ESD MEMO – CHANGE OF SOLAR PANEL LOCATION

PROJECT NAME: New Primary School in Edmondson Park
PROJECT NUMBER: 210104
ATTENTION: Daniel Vidovic
FROM: Gary Tang

Re: ESD Memo – Change of Solar Panel Location.

TITLE
ELECTRICAL SERVICES PROPOSED SITE PLAN

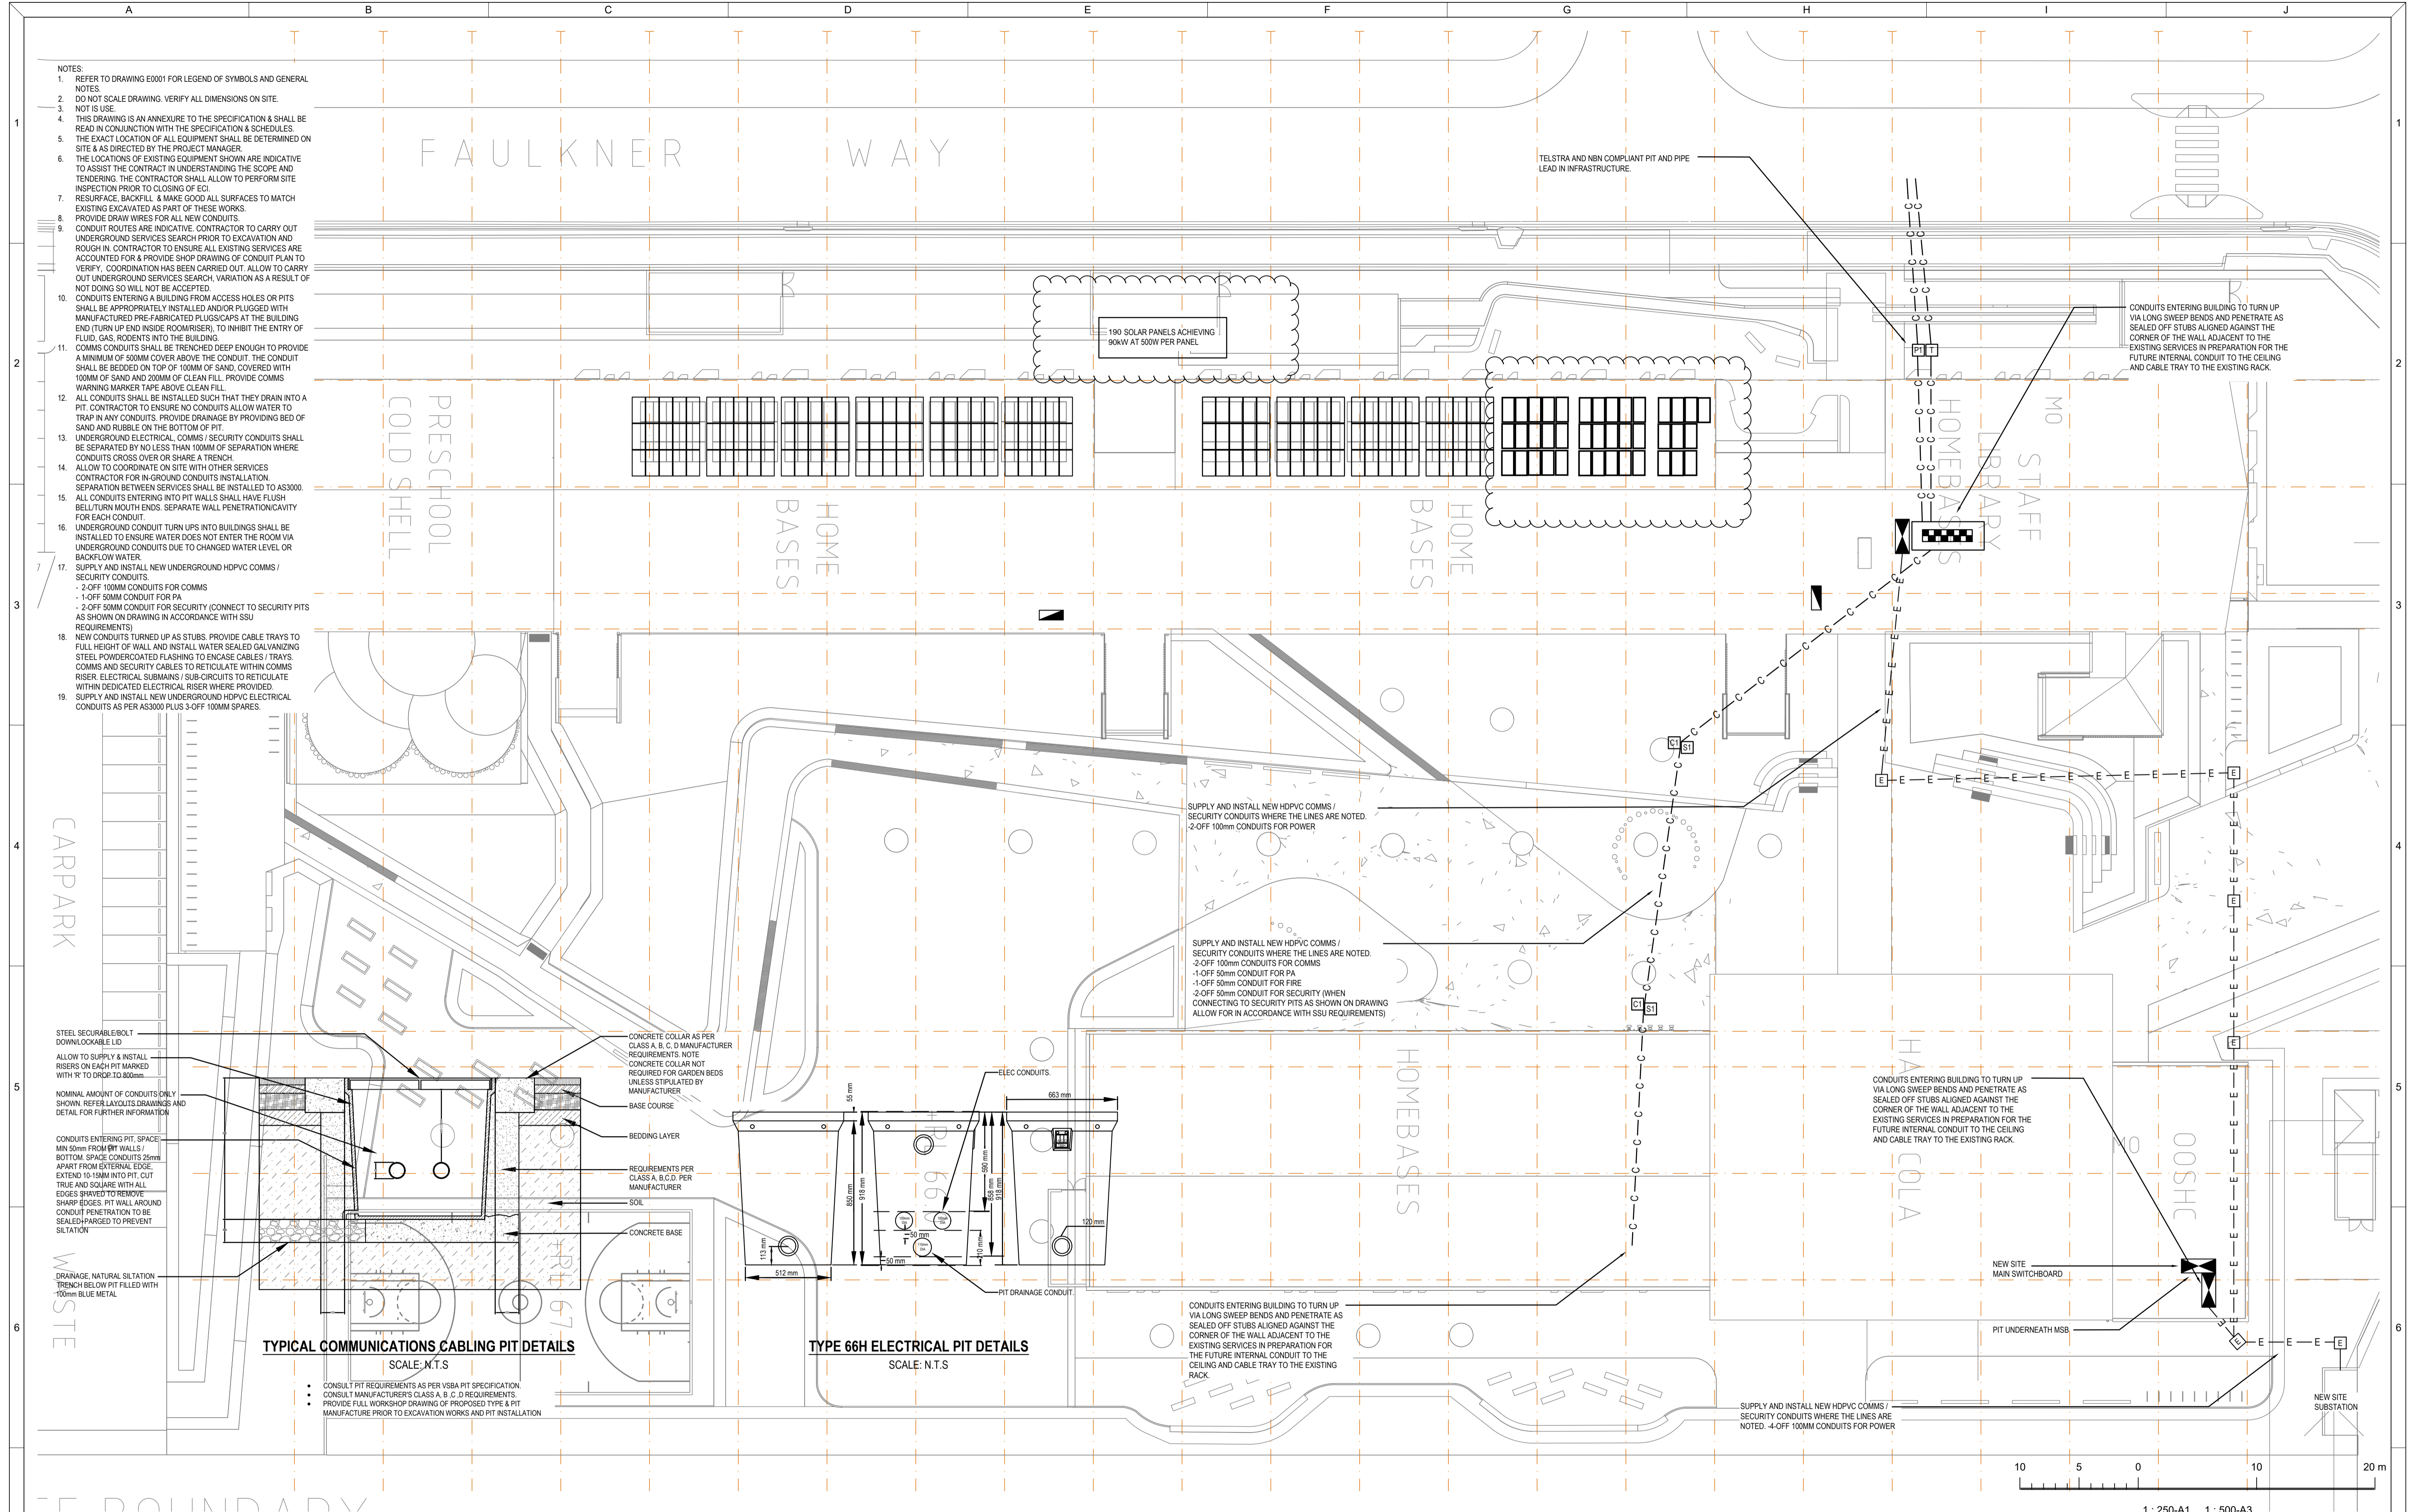
The project team proposed to amend the location of the roof solar panel from Hall Building to Building A (near Faulkner Way) with additional 20kW of PV panels to the system.

The drawing showing the new solar panel location is attached at the end of this memo.

JHA confirms this modification **will not** bring negative impacts on the environmental performance of the solar panel.
